HORSHAM DISTRICT COUNCIL CONSULTATION

TO:	Horsham District Council – Planning Dept
LOCATION:	Mowbray Phase RM7 Rusper Road Horsham West Sussex
DESCRIPTION:	Approval of details reserved by conditions 4, 6 and 8 to approved application DC/21/1427
REFERENCE:	DISC/25/0405
RE-CONSULT:	1 st set of comments in black 2 nd set of comments in blue
RECOMMENDATION:	Modification Modification / More information

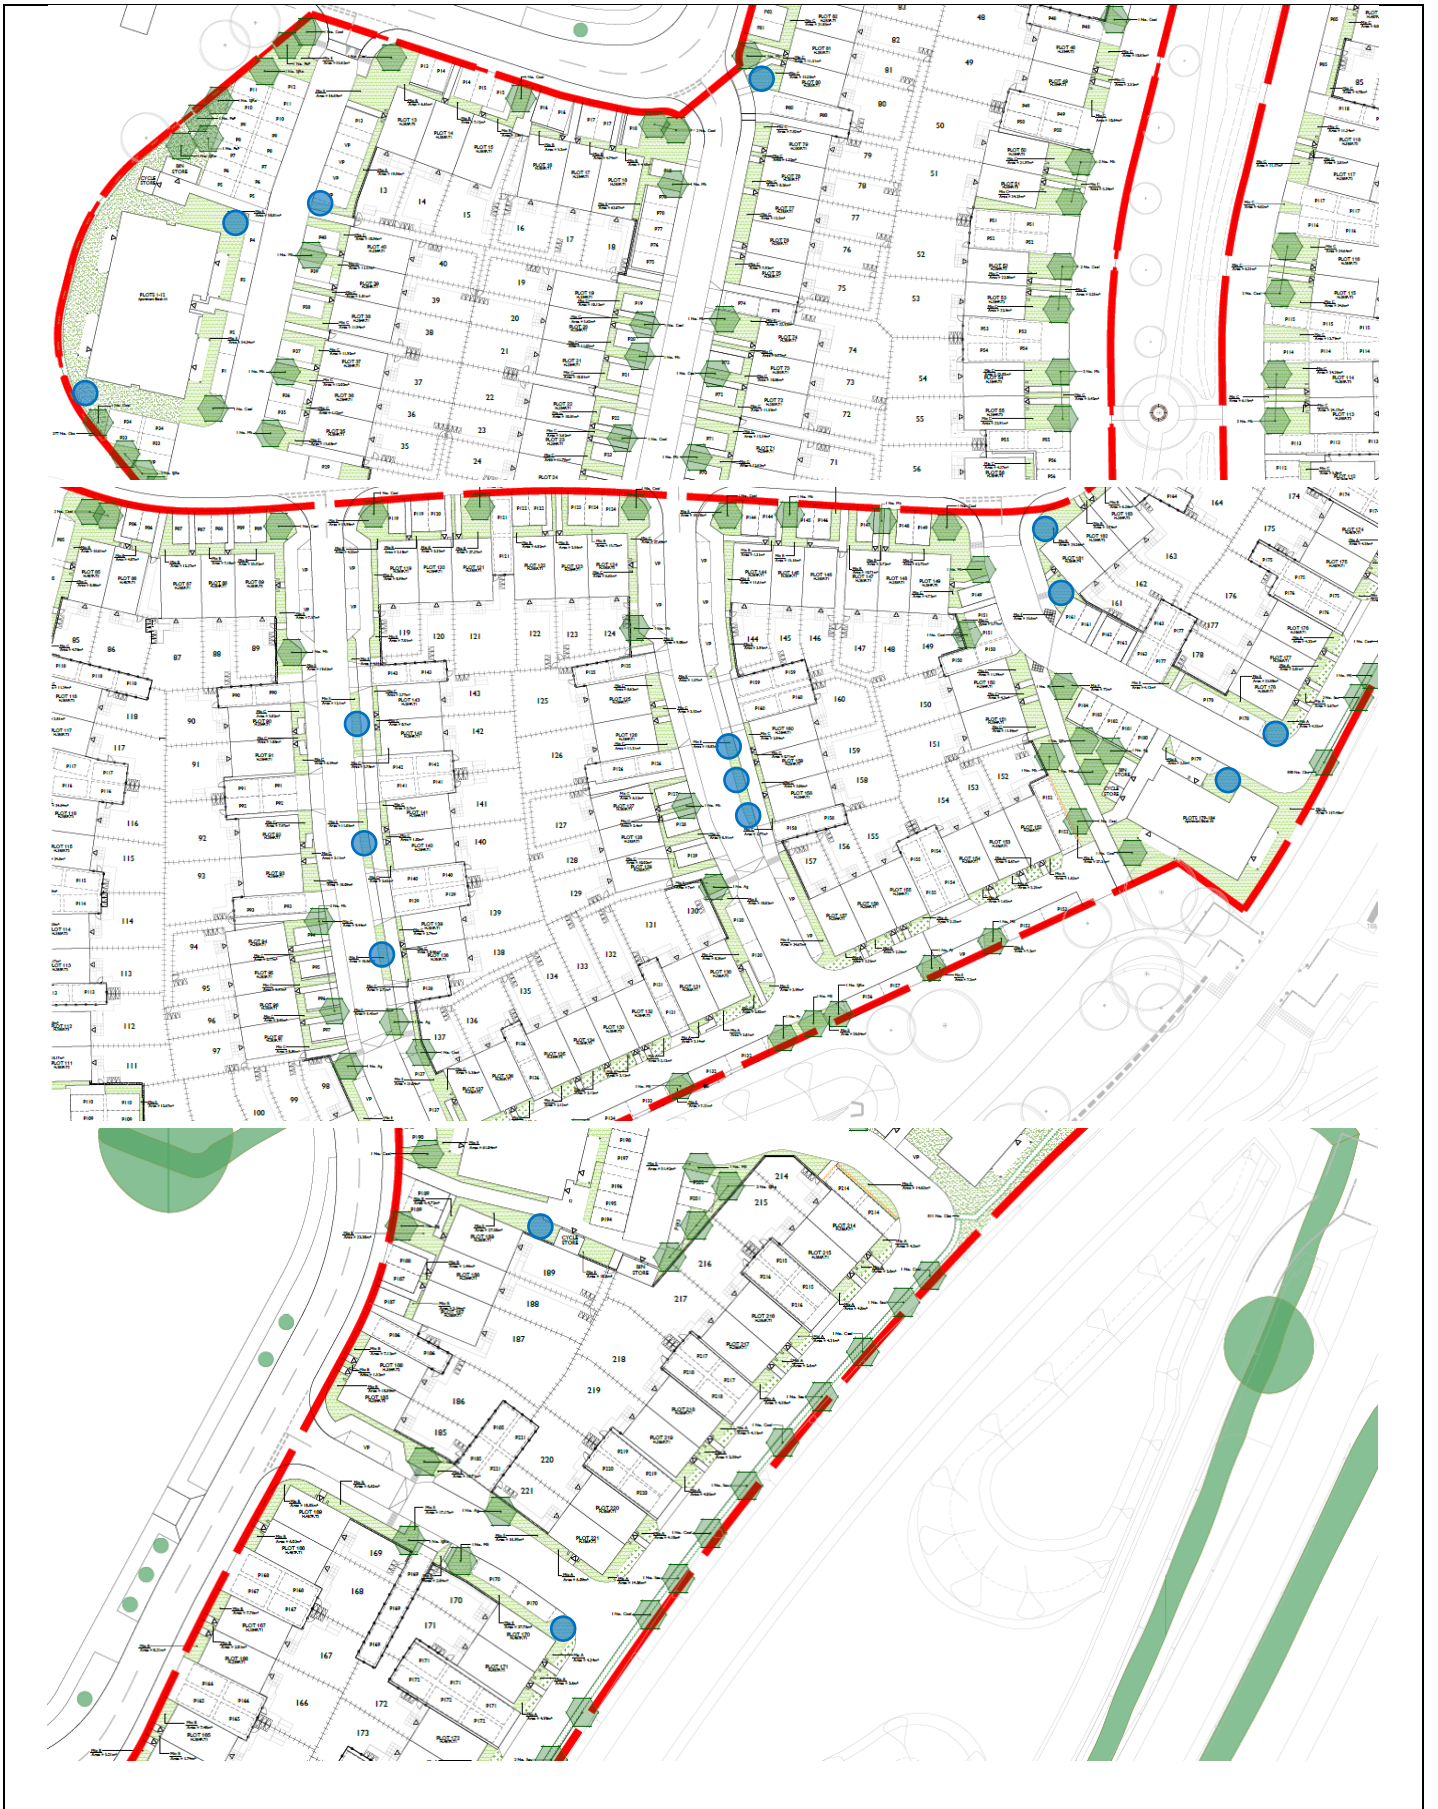
1. While the greater variety in tree species is welcomed, we note that 16no. trees are missing from proposals (please see blue highlights indicating locations below) which must be reinstated.

[Adjustments to locations notwithstanding, all trees have been reinstated, with thanks.](#)
[Closed.](#)
